WCAP-10989
Addendum 1

COBRA-NC, ANALYSIS FOR A MAIN STEAMLINE BREAK
IN THE CATAWBA UNIT 1 ICE CONDENSER
CONTAINMENT (RESPONSE TO NRC QUESTIONS)

MAY, 1988

Figure 1. Definition Sketch for Section B

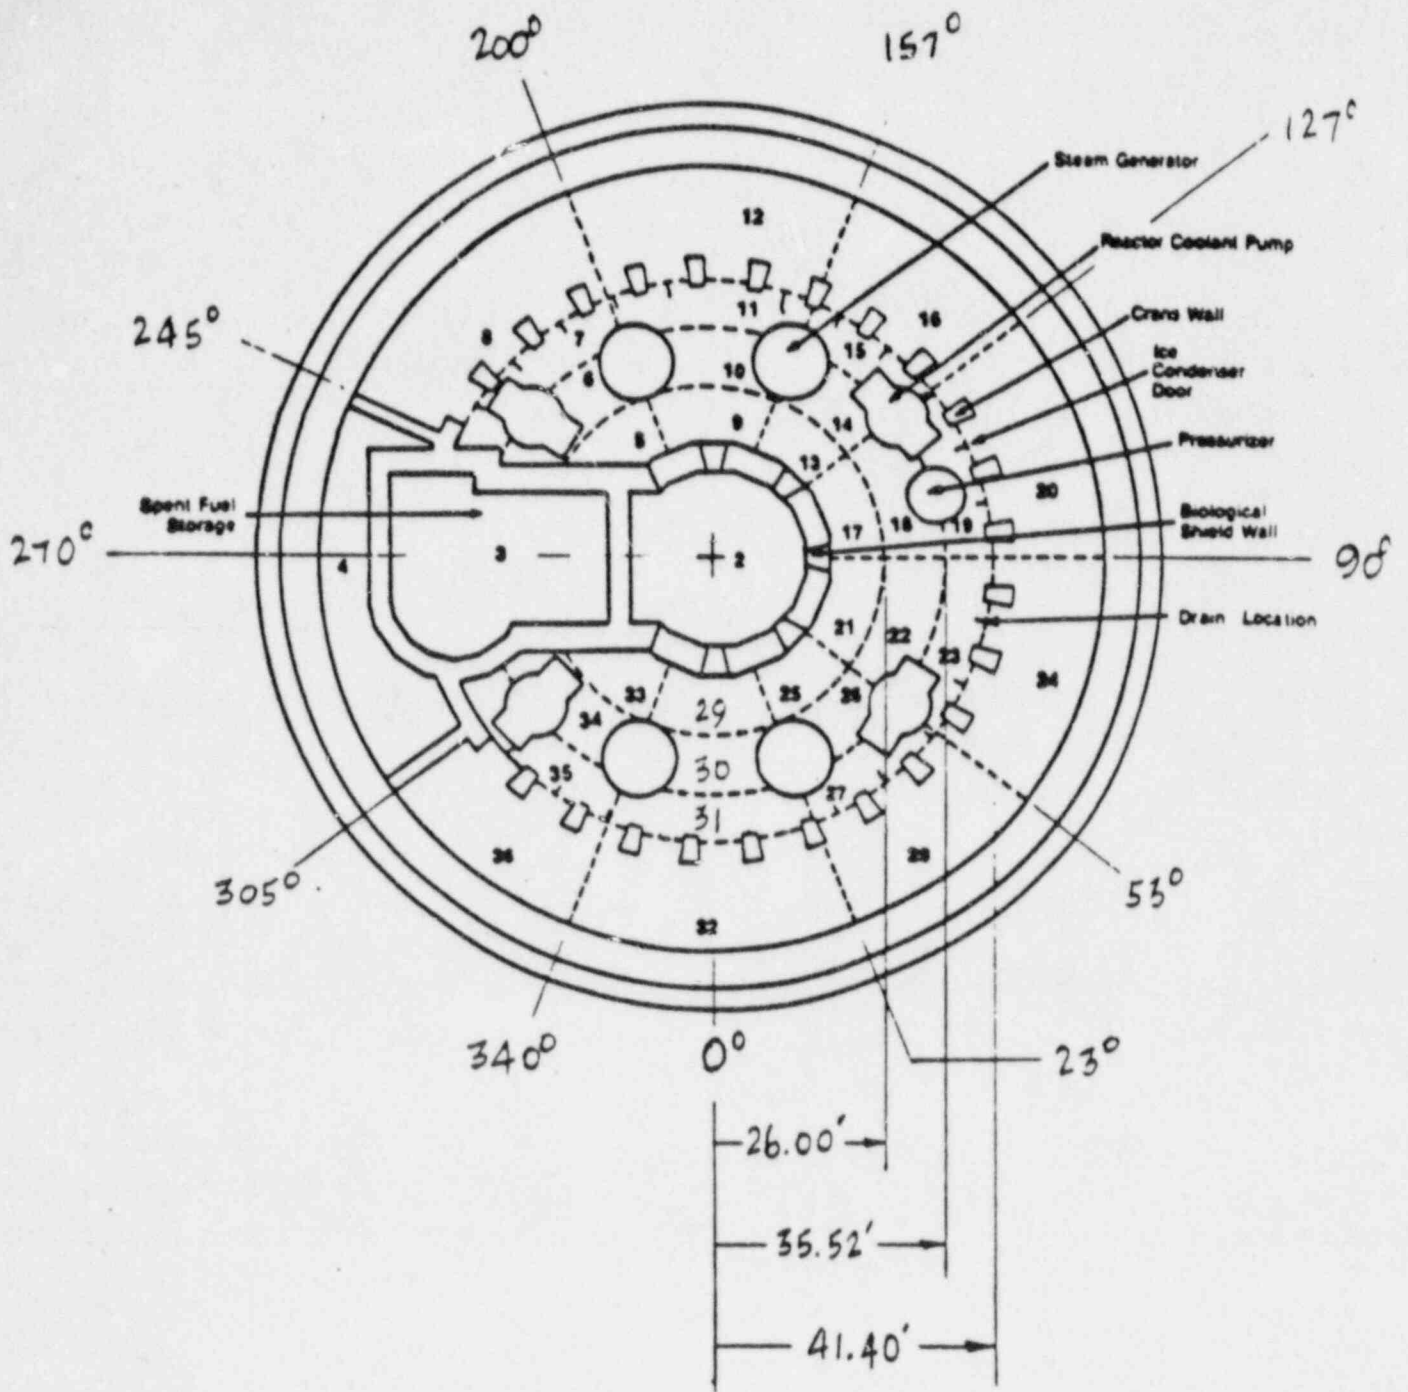
The values of Δr and $\Delta\theta$ in generating the computational cells as shown in Fig. 2.10.

Page 15: "The interior of the lower containment is divided into three radial rings and eight sectors." Provide the specific values of the radial (Δr) and circumferential ($\Delta\theta$) dimensions for each cell.

- (1) Figure 2.10 and Figure 5.4 are the same. There is no figure that describes the grid layout of Section B for the COBRA-NC/Model 2 in the report, while all data listed in Tables 5.2 and 5.3 is for Model 2.
- (2) On page 162, the physical structure in the middle figure is different from the other two.
- (3) The description of the ice condenser doors in the last paragraph of page 134 is not consistent with Figure 6.22.

The radii of the rings and the dividing angles are shown in Fig. 1 attached. Please see Fig. 1.

- (1) The subchannels 105-110 shown in Figure 2.10 should have been deleted, as shown by Figure 1 attached.
- (2) The drawings for the structure in the top and bottom figures on page 162 were in error. They should have been the same as that in the middle figure on page 162.
- (3) The last paragraph on page 134 should have been written as:

Figure 2. Definition Sketch for Gap

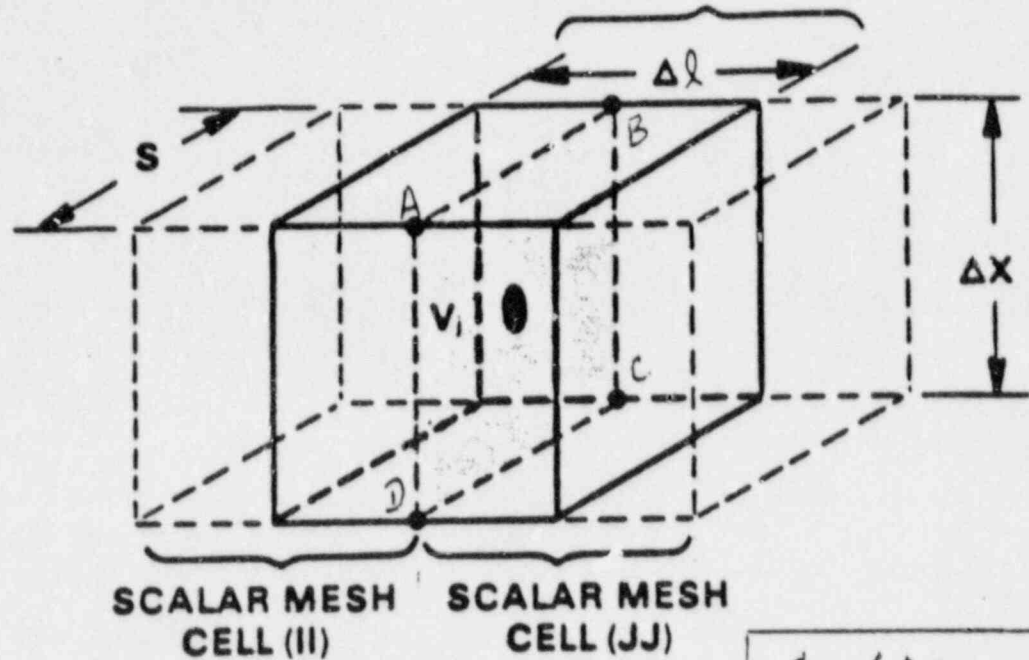
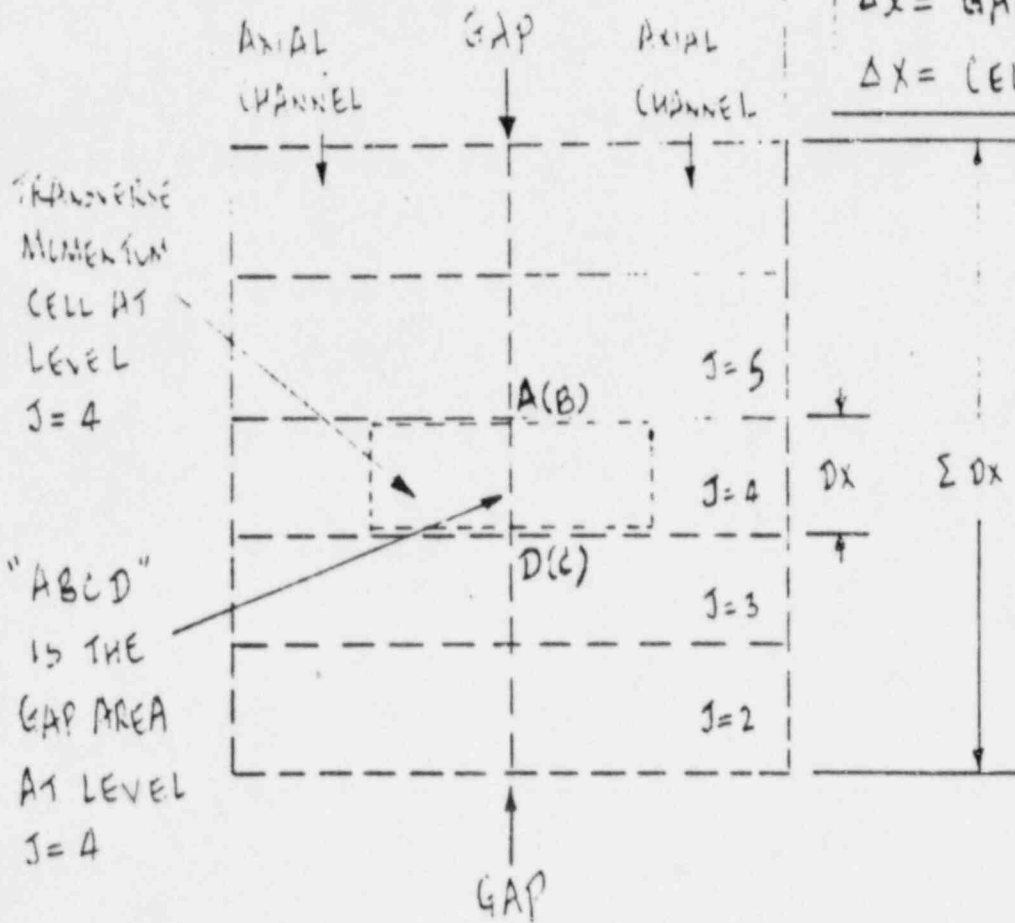
The actual flow area between cells.

The volume porosity for each cell in the COBRA-NC model is provided in Table 5.2, while the surface permeability is not available in the report, although the area multipliers and flow restricted area have been mentioned on page 75. Provide the actual flow area between cells for every cell in Section A, Section B, and vessel enclosures of Section C of the COBRA-NC/Model 3.

(See Figure 2 for gap definitions)

For the transverse directions, the flow areas are given by (gap width)*(cell height), as described in Response to Question 2 (2-3).
